Corrigendum 4 dated 02-04-2022 to Tender Specification BHEL PSSR SCT 2019

Tender Specification BHEL PSSR SCT 2019 - Balance works Civil, Architectural, Mechanical, Electrical, C&I and Other Allied works of including supply of material, labour, Tools & Plants etc for Package 1 (NDCT 2) & Package 2 (NDCT 1) of 2X660 MW Udangudi Super Critical Thermal Power Project.

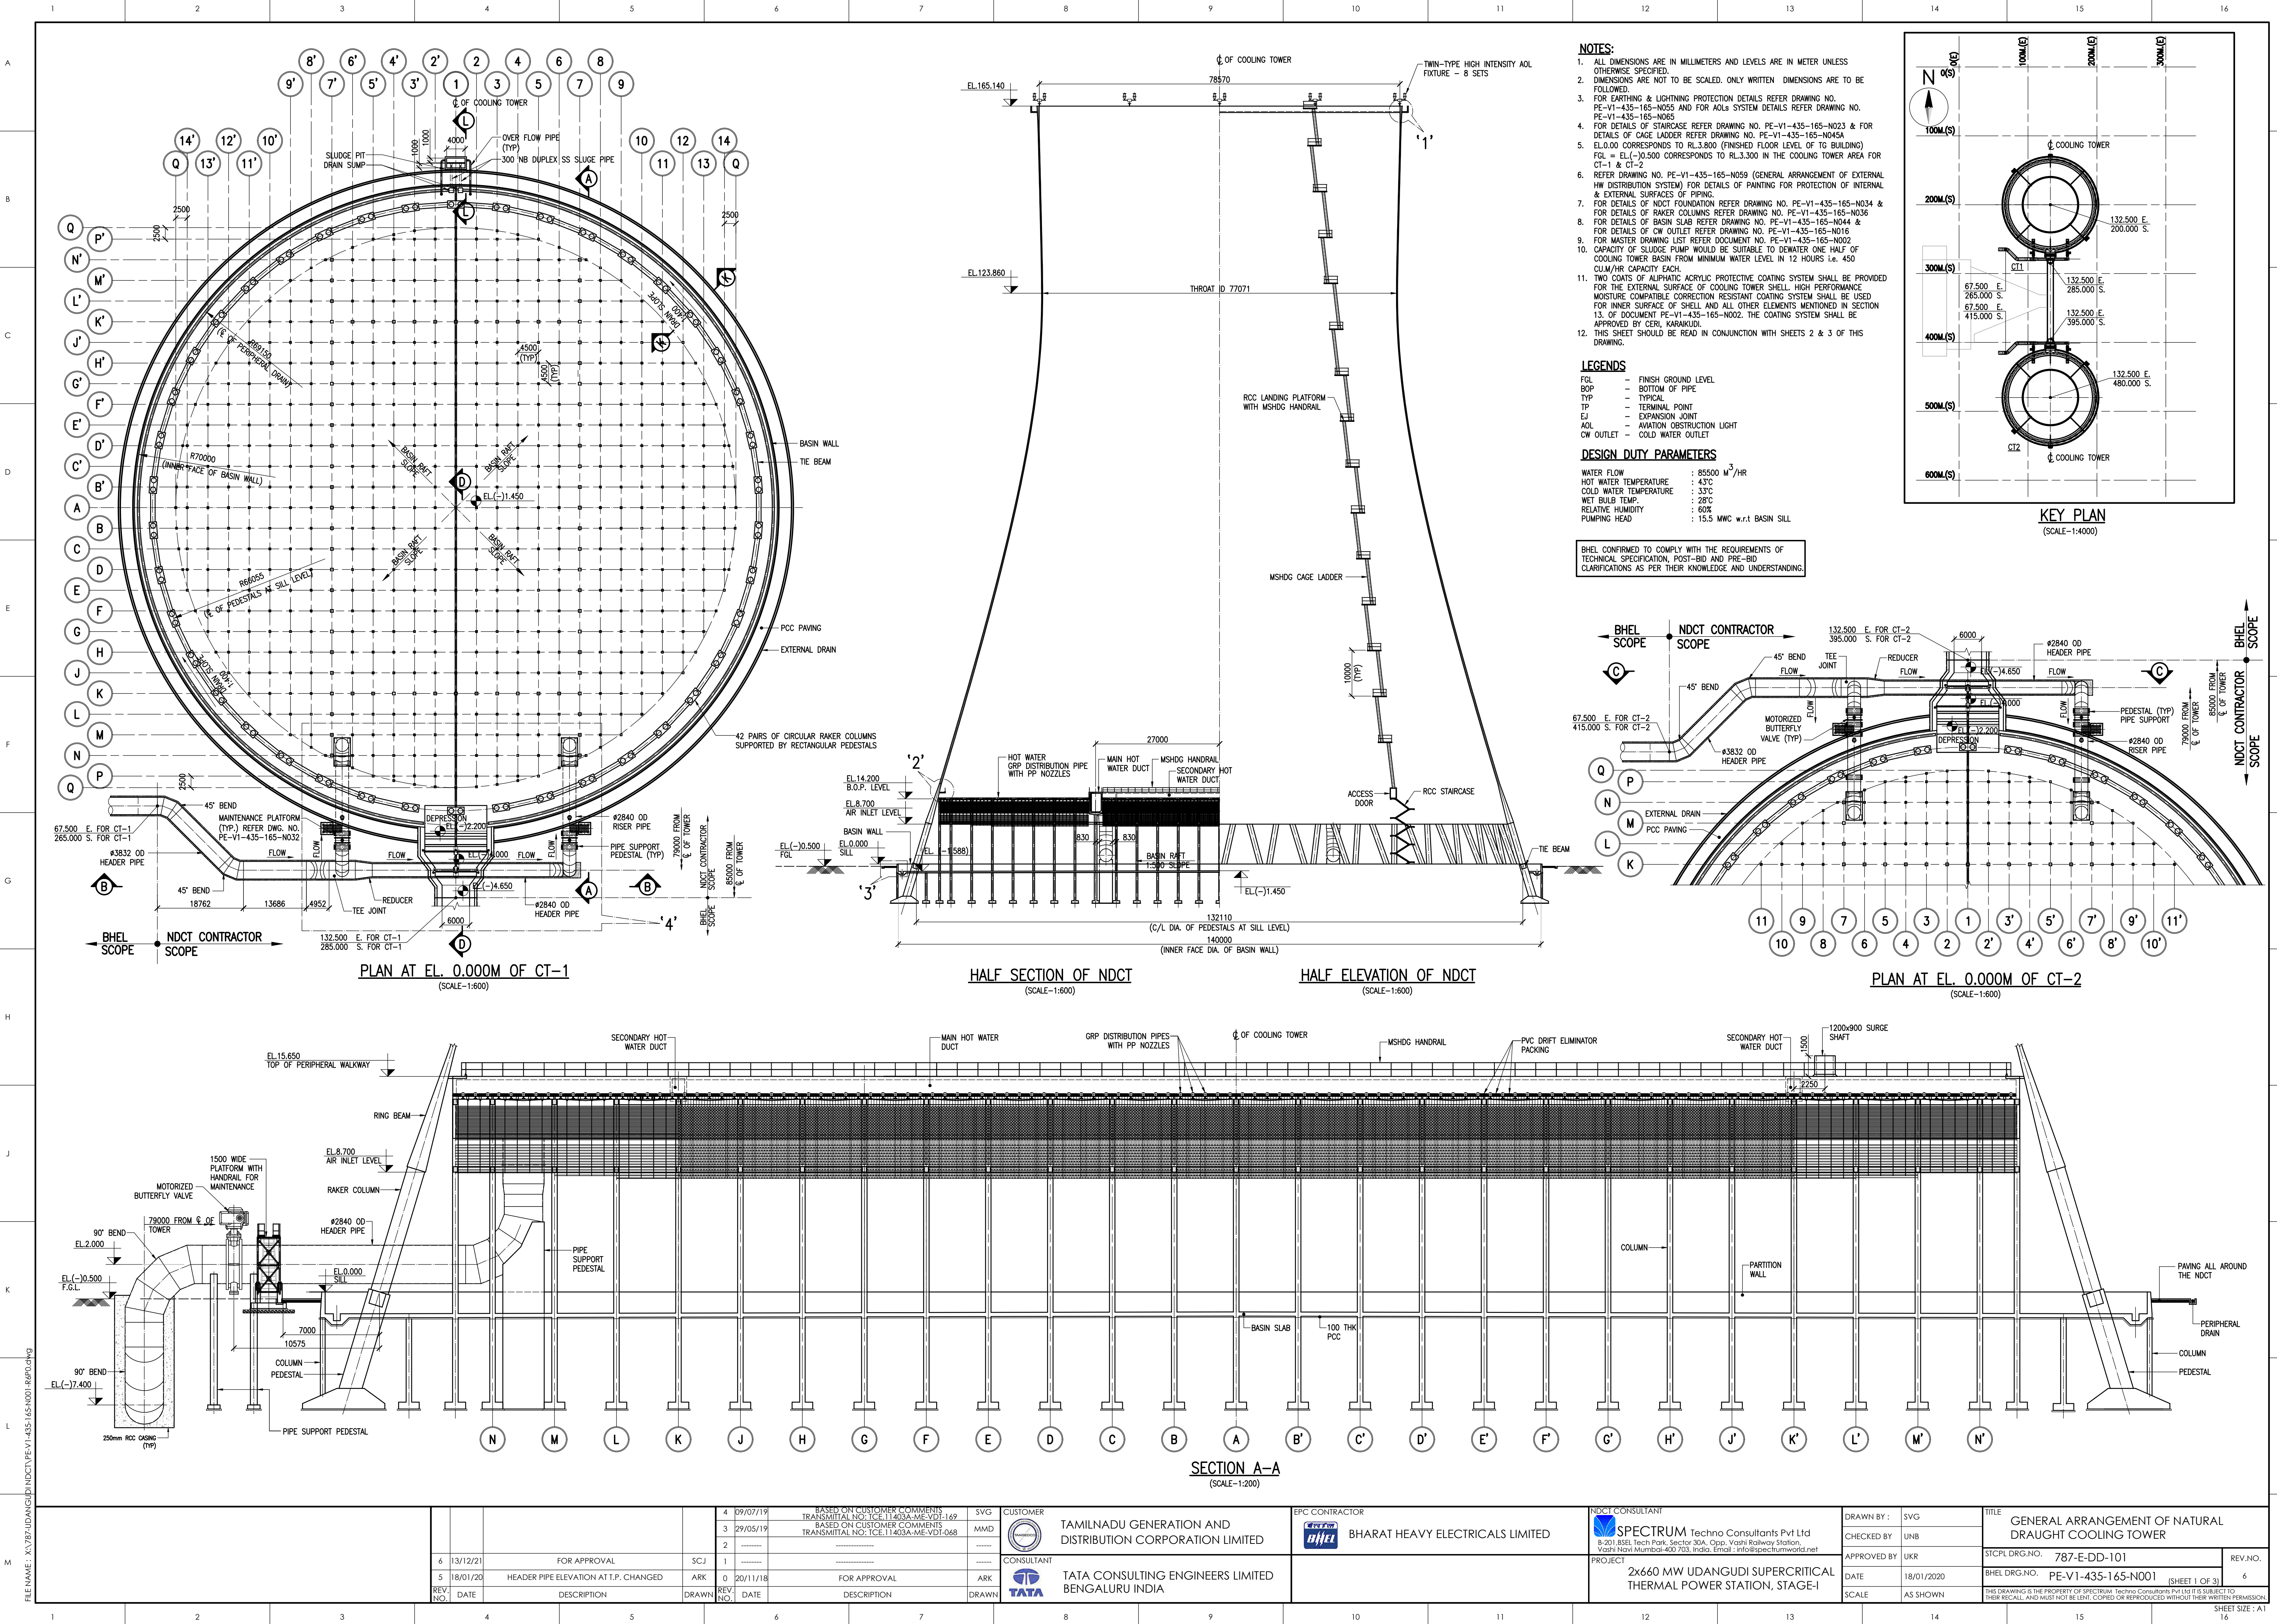
13	General	CONTROL & INSTRUMENTATION FOR SUMP PUMP SYSTEM	Instruments required for performance guarantee testing of the cooling tower(s) will remain the property of the testing team of the contractor and will be taken back by the contractor after the test. Please confirm.	Noted for Testing Instruments only.
